**SUBJECT: FINAL TRIP REPORT—DECOMMISSIONING INSPECTION OF THE  
HOMESTAKE MINING COMPANY OF CALIFORNIA, GRANTS, NEW  
MEXICO (RFTA NO. 96-16)**

**TRIP REPORT  
DECOMMISSIONING INSPECTION OF THE  
HOMESTAKE MINING COMPANY OF CALIFORNIA  
GRANTS, NEW MEXICO**

FIGURE 8: Area D74063 and D74077 - Measurement and Sampling Locations

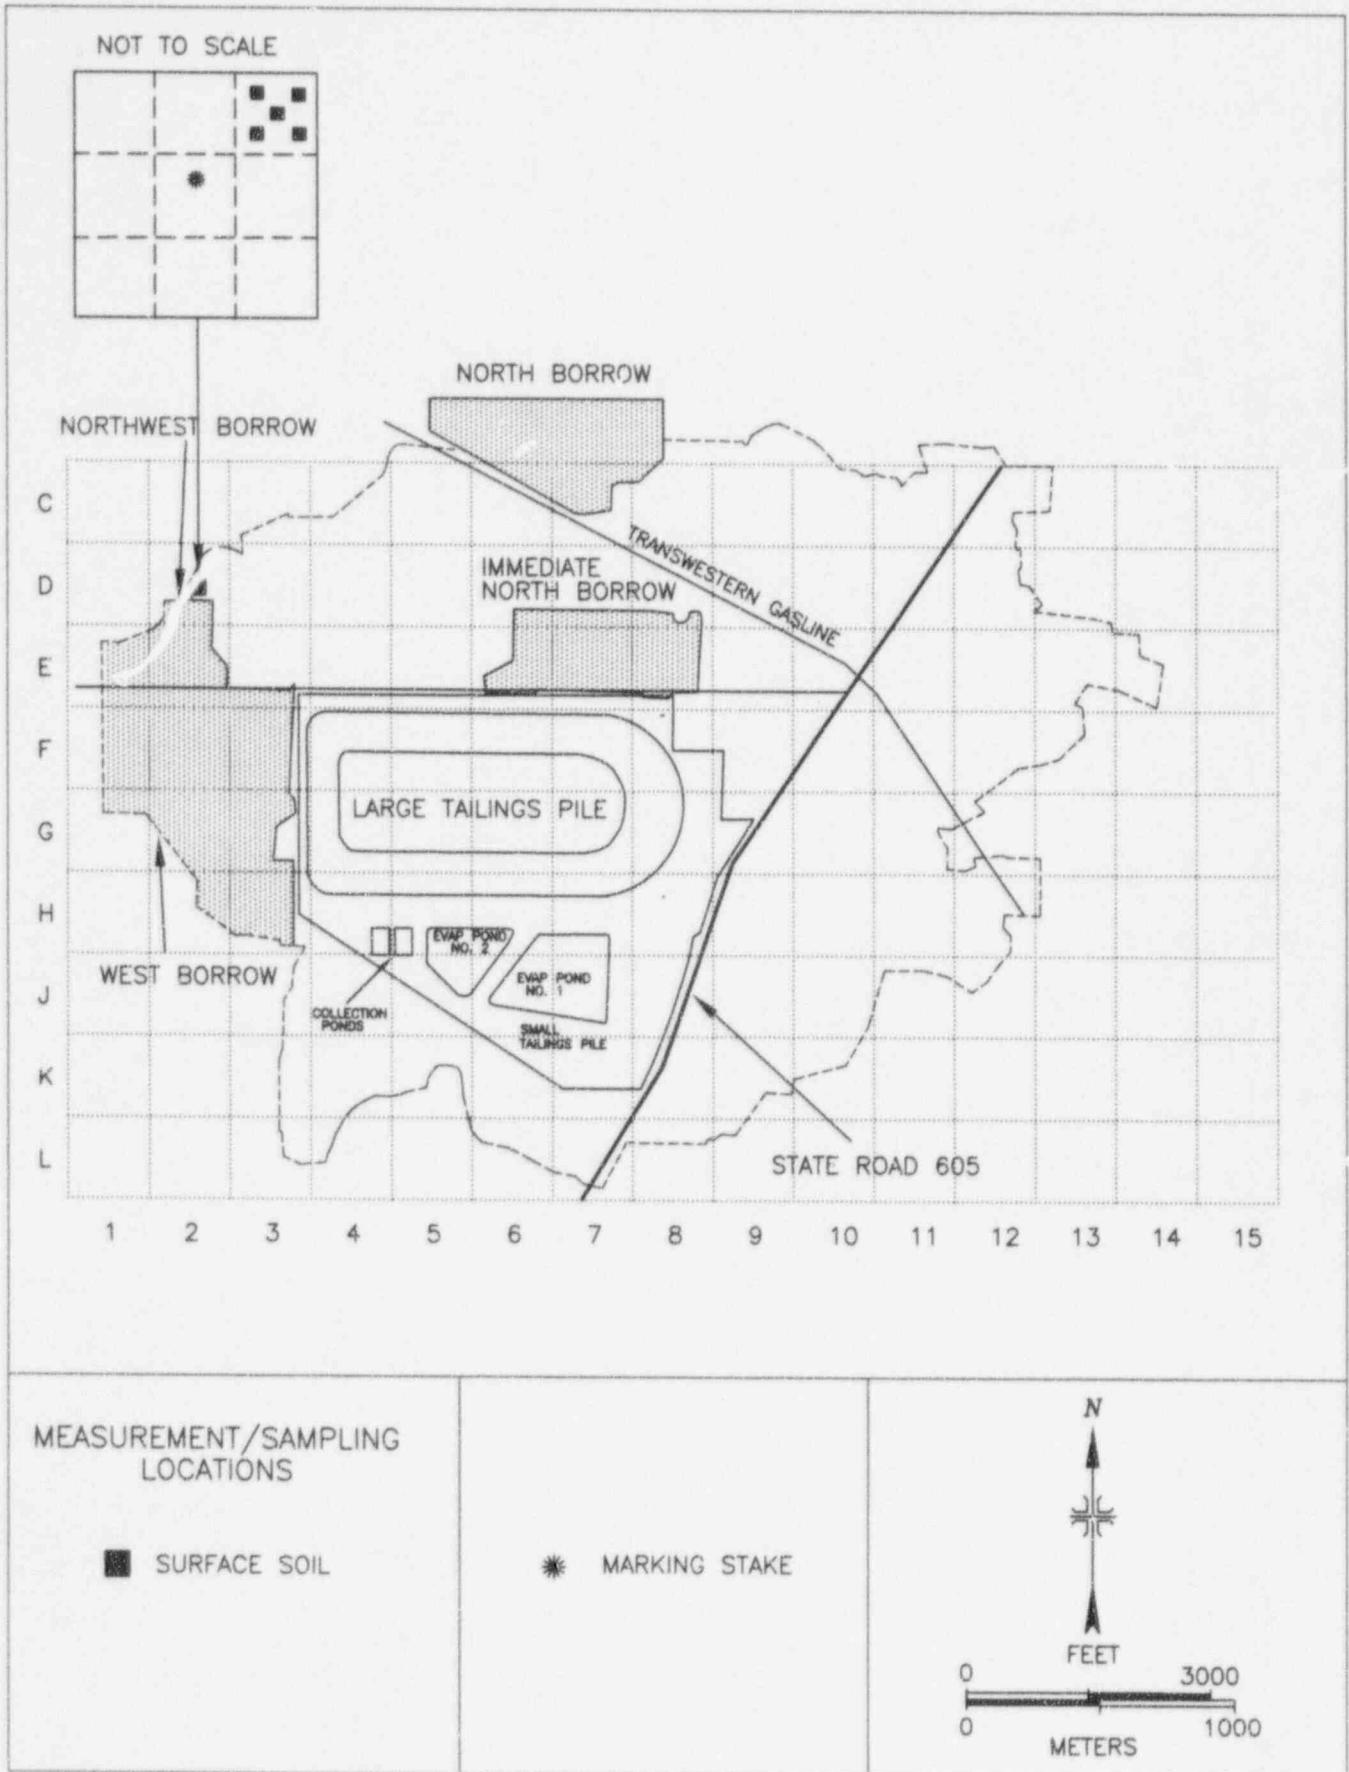
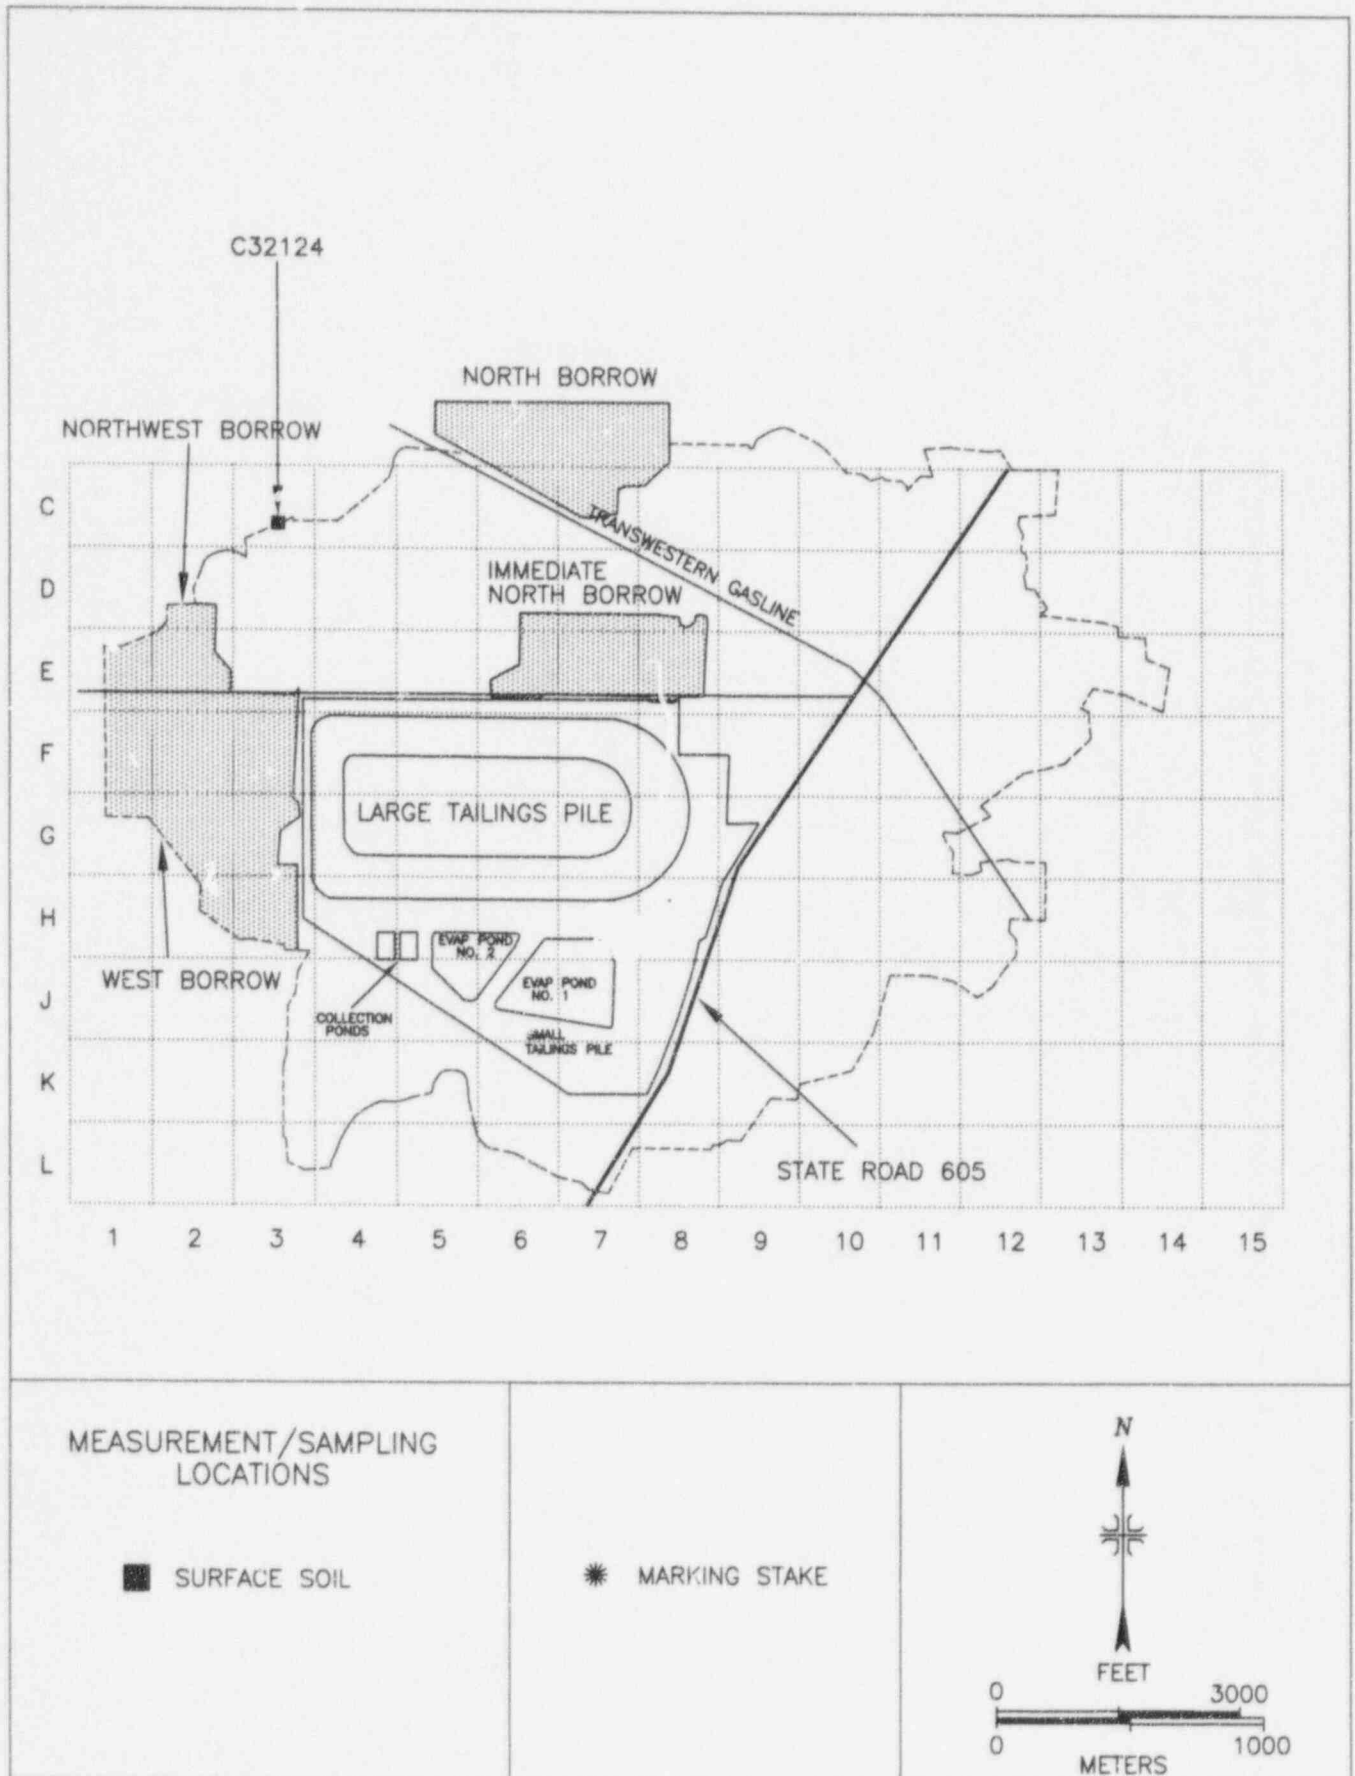
- 6.4 Perform gamma readings with a  $\mu$ R meter at random and suspect locations, in windblown areas and on cell covers.
- ESSAP performed gamma surface scans over seven 900 m<sup>2</sup> areas—selected on the basis of the licensee's data indicating potential anomalies—within the Outer Zone (Figures 1 through 9) and seven areas within the buffer zone and  $\mu$ R/h measurements were performed at 40 locations within the Outer Zone. These measurements are provided in Table 1. No measurements were made on the pile covers.

Gamma scans identified a number of locations of elevated direct radiation within surveyed areas from which ESSAP collected composite samples from the 100 m<sup>2</sup> area associated with each anomaly (a total of eight samples were collected from the seven surveyed areas). These samples were processed by the licensee and split samples prepared for confirmatory gamma spectrometry analysis by the licensee and ESSAP. The licensee was requested to collect a sample from an eighth area identified within the buffer zone. An additional sample was collected by the licensee and provided to ESSAP for analysis on November 7, 1996.
